Contract #: 04-0120F4Cty: SF/ALA Rte: 80 PM: 13.2/13.9File #: 69.25B**QUALITY ASSURANCE -- NON-CONFORMANCE REPORT****Location:** Changxing Island, Shanghai, P.R. China**Report No:** NCR-000238**Prime Contractor:** American Bridge/Fluor Enterprises, a JV**Date:** 28-Mar-2009**Submitting Contractor:** Zhenhua Port Machinery Company, Ltd (ZPMC), Changxing Island**NCR #:** ZPMC-0212**Type of problem:****Welding****Concrete****Other****Welding****Curing****Procedural****Bridge No:** 34-0006**Joint fit-up****Coating****Other****Component:** Segment 1BE: Floor Beam to Bottom Plate**Procedural****Procedural****Description:****Reference Description:** QA Inspector found additional MT indications**Description of Non-Conformance:**

Job Name: SAS Superstructure

Subject: NCR No. ZPMC-0212

Reference Description: QA Inspector found additional MT indications

Component: Segment 1BE: Floor Beam to Bottom Plate

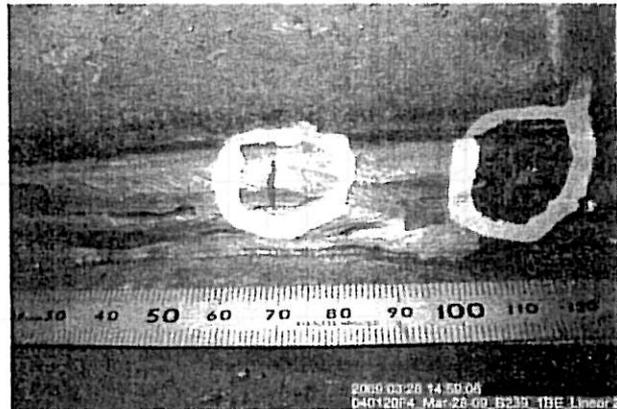
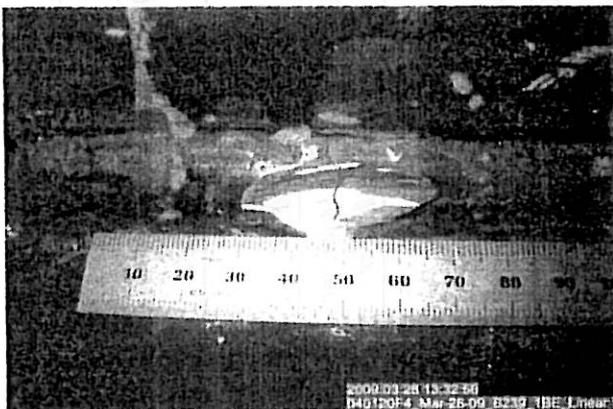
During random verification Magnetic Particle Testing (MT) of floor beam to bottom plate weld numbers SSD45-PP10.5-107, SSD49-PP12-106 and SSD49-PP12-107, Caltrans Quality Assurance (QA) Inspector discovered a total of eight (8) transverse linear indications ranging from 10 to 30mm in length. These linear indications were not found when Contractor performed 25% MT inspections.

AWS D1.5 (2002) - Section 6.26.2, "Welds that are subject to MT in addition to visual inspection shall have no cracks."

Component: Segment 3AE Corner Assembly

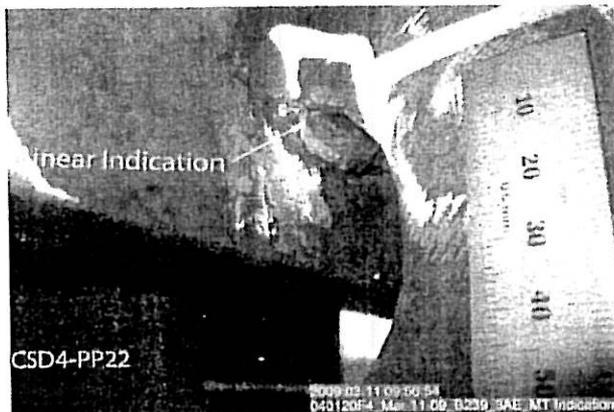
On March 10, 2009, ZPMC Quality Control (QC) representative Mr. Wang Lu notified Caltrans Quality Assurance (QA) inspector of the re-inspection of the corner assembly components by Magnetic Particle Testing (MT) of the linear indications discovered by QA inspectors on Segment 3AE Green Tag #8. Caltrans QA performed MT the second time on the following corner assembly welds: CSD4-PP22-069, CSD4-PP22-071, CSD4-PP22-073 and CSD4-PP22-134. Caltrans QA Inspector discovered additional linear indications ranging from 10 to 25mm long.

AWS D1.5 (02) Section 6.26.2 – “Welds that are subject to MT in addition to visual inspection shall have no cracks.”

项目名称 Project Name:	美国海湾大桥 SFOBB	部件图号 Drawing No.:	SEG006A	报告编号 Report No.:	B-CWR451
合同号 Contract No.:	04-0120F4	部件名称 Item Name:	PLATE PANEL SPLICE	NDT 报告编号 NDT Report No.:	B787-MT-8741
项目编号 Project No.:	ZP06-787

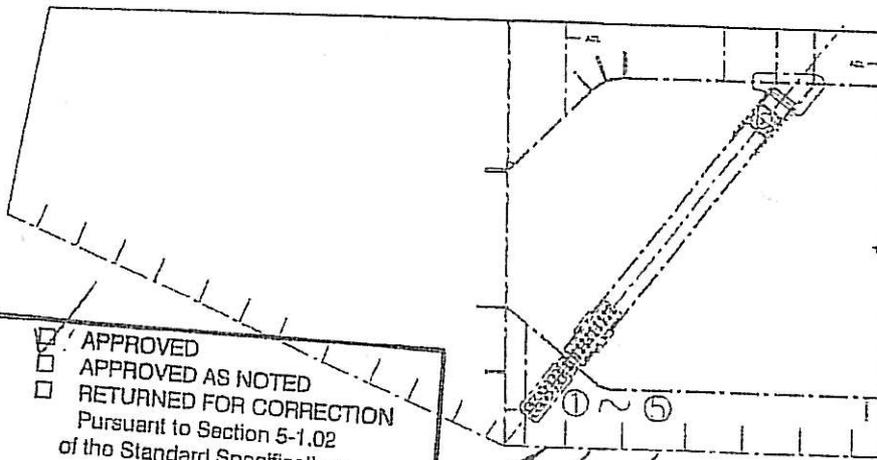
In welds SSD49-PP12-106/107/108/109/110, a transverse crack was detected by MT in each weld. X, Y show the distance on X, Y axis.

In welds SSD49-PP12-106/107/108/109/110, transverse cracks were detected by MT in each weld. Please see the detail position in the sketch below. The details are as following.

5. Remove all indications by grinding.
6. Grind repair areas smooth to a shiny finish with tapered ends to ensure staggered stops and starts.
7. Perform VT and MT inspection.

8. QC and a Lead CWI shall verify and document all indications have been removed prior to repair welding.
9. Follow the repair WPS for preheat and weld deposition.
